# Your feedback on Nelson Street cycleway - phase 3 Market Place

# 1. Summary

From 13 February– 8 March 2020 the public were invited to provide feedback on a proposed two-way physically separated cycleway along the western side of Market Place between Pakenham Street East and Custom Street West in the city centre. In total **554 submissions** were received.

**NELSON STREET PHASE 3  
CONCEPT  
ZONE PLAN - MARKET PLACE**

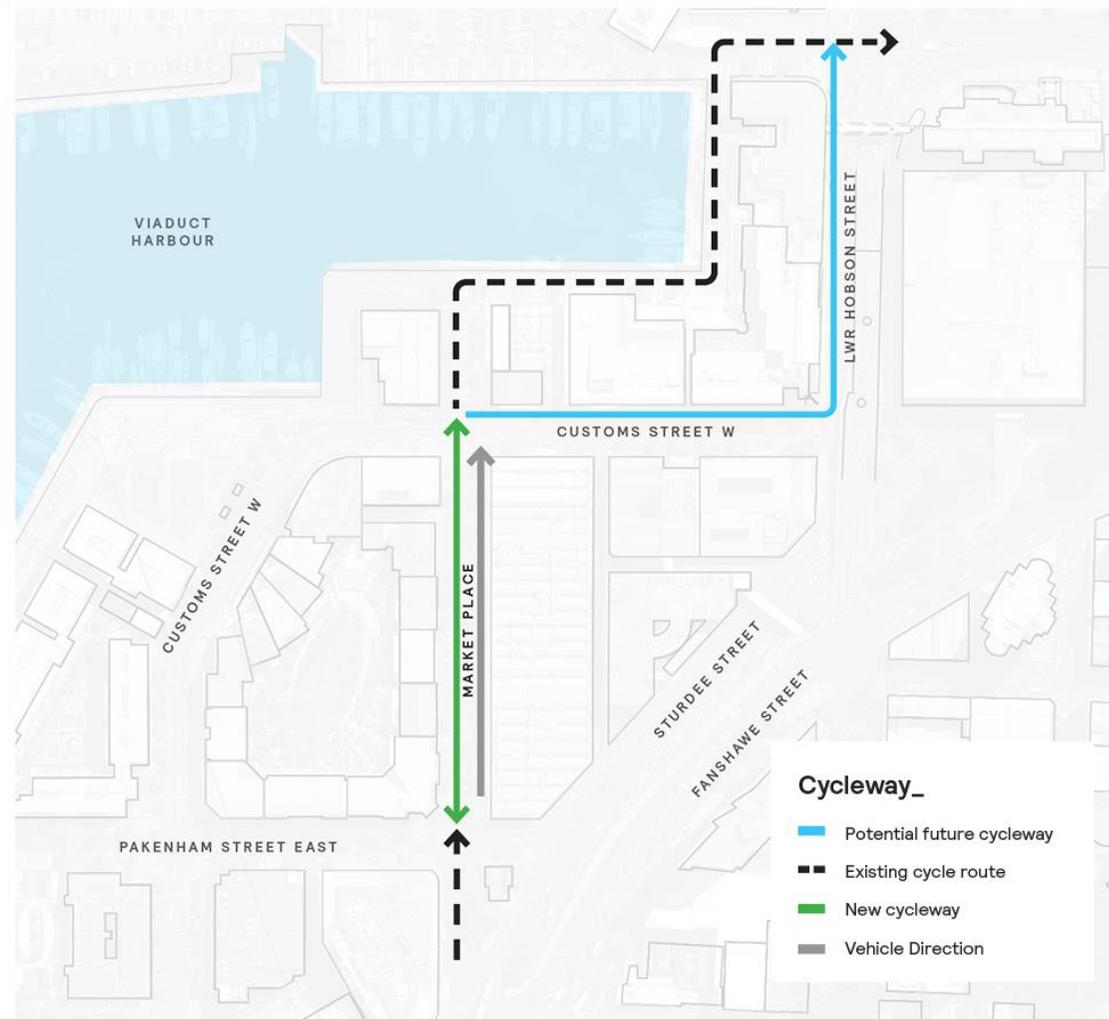
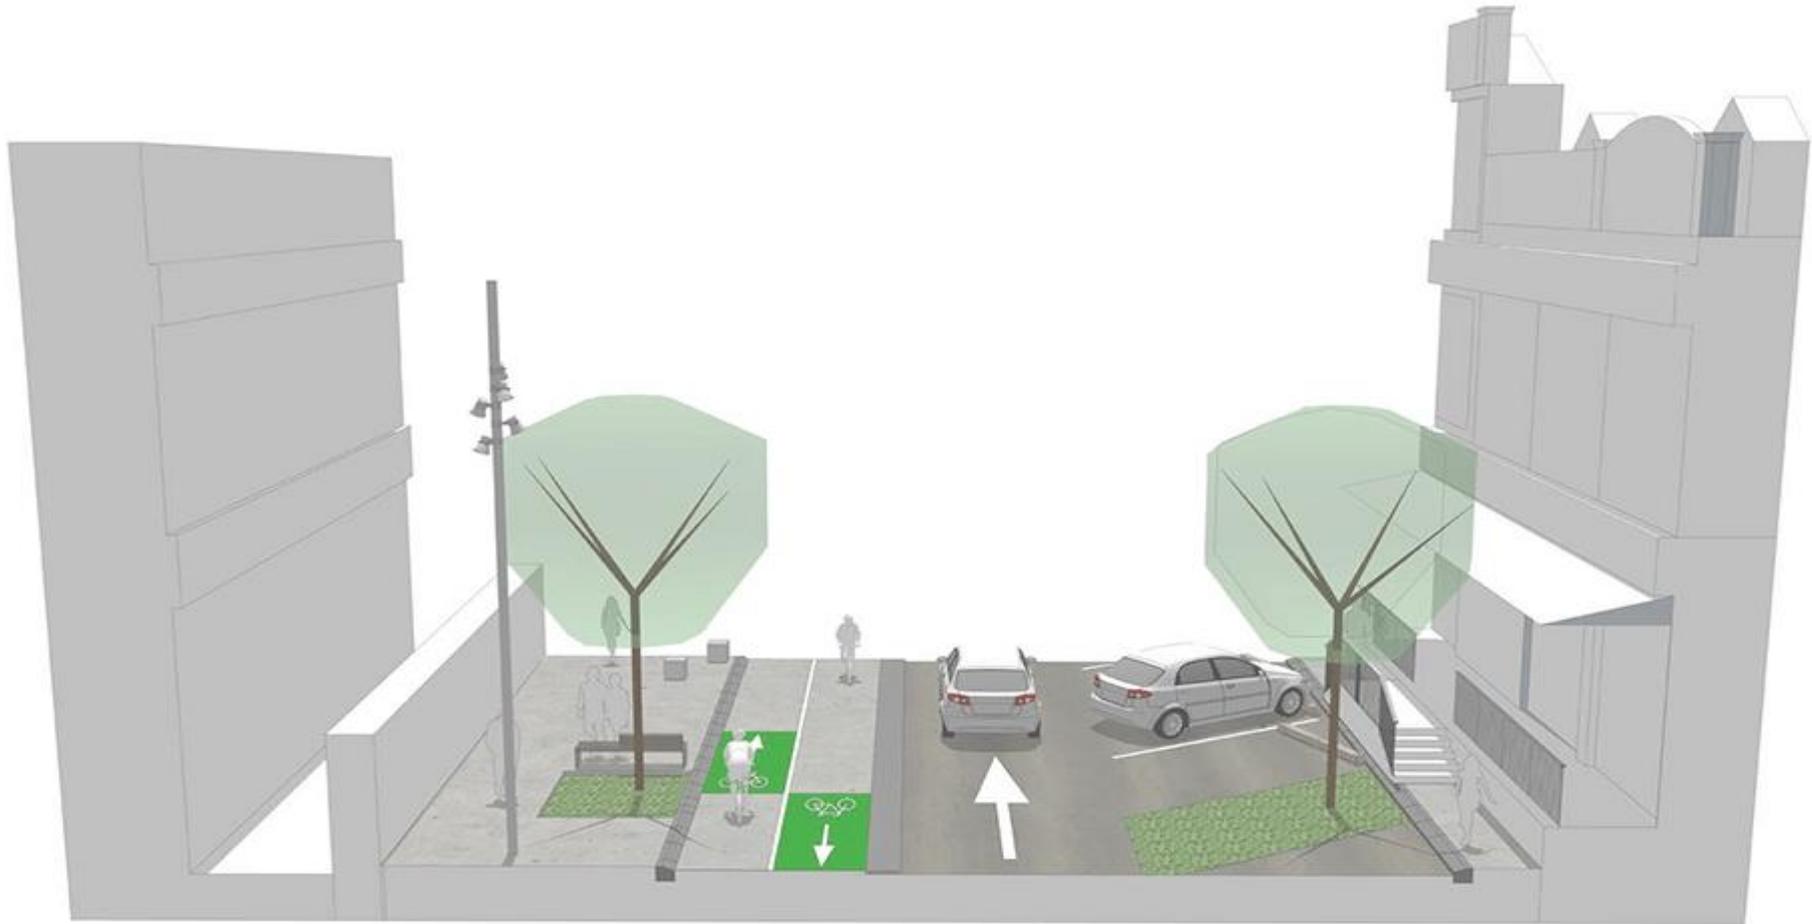
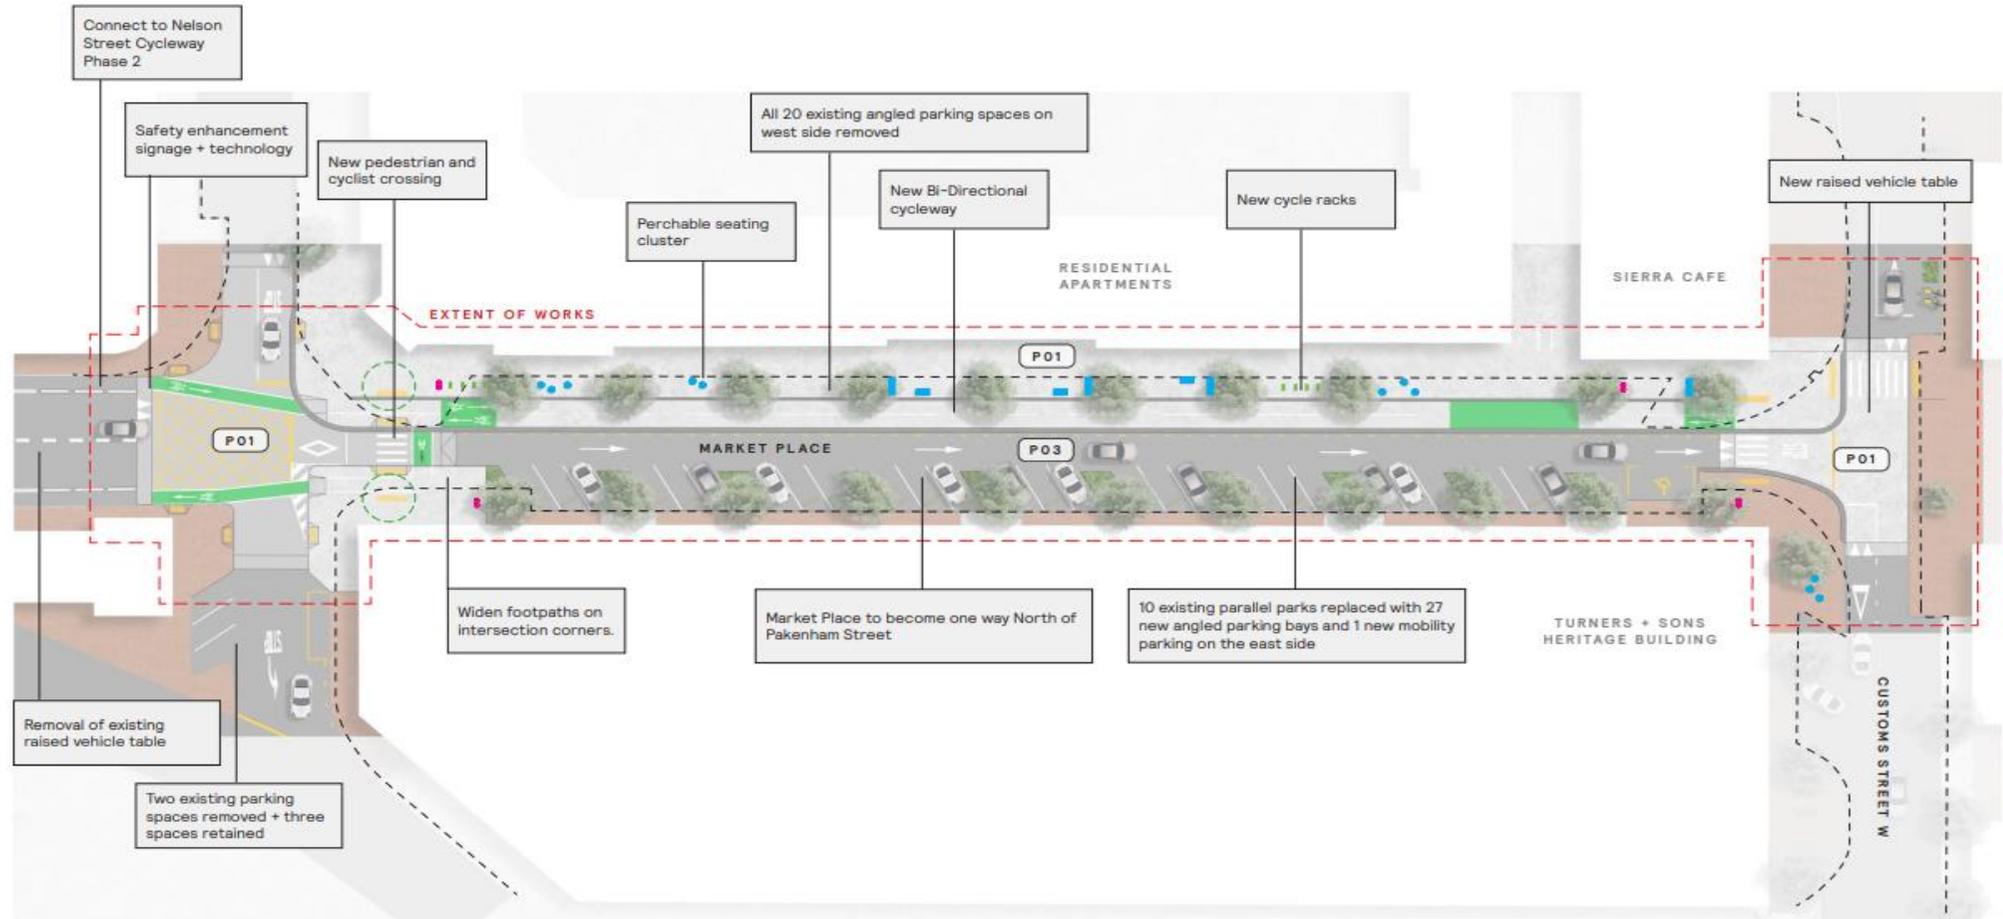
Bike Auckland supports this project on the condition that it is delivered with a full connection through to Quay St. For ease of access and for the safety of everyone, we cannot support a truncated project that funnels additional people on bikes and scooters into the busy Viaduct Area when it is likely to be most crowded with people on foot.

- 1) bridging the gap to Quay St
- 2) an improved design for the crossing near the intersection with Pakenham St East,
- 3) a request for a robust curb treatment on Market Place.

The lack of the 'final' connection to Quay Street, however, fatally undermines this. Pushing bicycles into the people dense viaduct entertainment district invites conflict, and expecting everyday people, including our families and children, to use the unchanged Customs Street West and absolutely awful Lower Hobson Street is disappointing. As such we support the proposal on the assumption that the remainder of the initial stage 3 proposal (i.e. connectivity along Custom Street West and Lower Hobson to Quay Street), with a range of comments relating to specific concerns based on our daily experiences.

The first concern is that there is a 100% likelihood of the cycle lane being used as a loading zone and short-term parking in the current proposal. The lack of mobility and loading zones on the street will ensure this outcome. We request that Loading zones be provided at both ends of the street (consistent with ATs Loading and Servicing Strategy) and that physical barriers be in place to prevent vehicles from entering the cycle lane and the newly widened footpaths, especially at the corners. These are not hypothetical concerns to residents who are negatively affected by this issue daily.

The second issue is the lack of walking priority at the southern intersection and a safe crossing missing from the northern intersection. We request that the intersection with Pakenham Street have painted zebra crossings provided on the three remaining legs. Movements onto the 'island' at the south east end of the proposed work area are frequent for people getting to the Northbound Northern Express bus stops on Fanshawe Street and the current design persists in prioritising car (and bicycle) movements over people walking.

Regarding the cycleway design, there are two areas of concerns – one at the north end and one at the south. At the northern end the cycleway just ends. In the previously consulted on document there was provision for a prioritised crossing for people on bicycles, but that is now missing. This means that people on bike are required to dismount and use the pedestrian phase or enter the road space. We request that the cycleway continue across Customs Street West (with priority over cars) to at least get people safely to the viaduct.

At the southern end there are a handful of concerns related to the visibility of people on bicycles and the awareness/focus of people in cars. The current raised table is inadequate to sufficiently slow vehicles and we ask that the replacement is at a gradient that better achieves the desired speed reductions.

The bike lane needs a higher concrete divider between it and the road, plus plastic flexi-sticks, to prevent illegal parking.

Pakenham St East/Market Place intersection is a good start but doesn't go far enough. The one lane entry for private vehicles into the new Market Place route should be rotated slightly to be diagonal, to

The current design is missing a crucial leg: a protected cycleway linking Market Place and Quay St that passes through Customs St West and Lower Hobson St. This leg could be easily installed adding planter boxes and removing parking on one side of the road to form protected bike lanes.

- We are investigating options for a temporary cycleway on Market Place, Customs Street West and Lower Hobson Street to provide a full cycleway connection to the Quay Street cycleway before a permanent connection is investigated. This will be subject to funding and we will work closely with stakeholders to design the best outcome.

- We will use higher separators to separate the cycleway from the road which will better prevent parking on or near the cycleway
- We have updated the seat locations and type in order not to encourage mid-night gatherings near residential properties.

- We have updated the number and location of rubbish bins.
- We are shifting the pedestrian crossing at Market Place/Pakenham Street intersection further north which will mean we can retain the existing two trees.

- There will be a loss of one additional carpark at the southern end of Market Place due to retaining the two existing trees at entrance to street.
- There are two other trees on the cycleway side of Market Place that are leaning. These two trees will need to be removed so they don't cause a safety hazard to cyclists however they will be replaced with three trees in the same area.

- We will provide additional pedestrian and bike crossings at Custom Street West/Market Place intersection.
